Hi-Fi Products  
Service Bulletin

**Model:** RM-P700

**No. 91**

**Subject:** Unit Will Not Learn

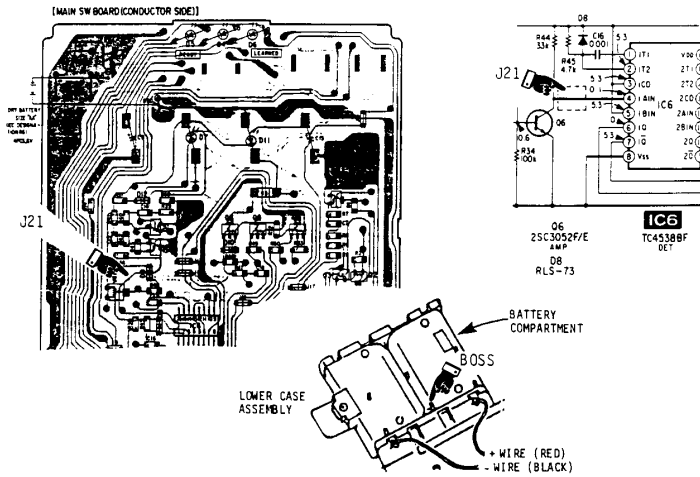
**Cause:** The detector circuit does not receive any signal. Chip jumper J21, which connects the collector of Q6 and pin 4 of IC6, may have broken down due to the stress exerted by the board holder's boss.

**Note:** J21 has not been indicated on the board. Refer to the figure below for its location.

- Solution:**
1. Remove J21 and connect the two points with a wire.
  2. Cut away the board holder's boss.
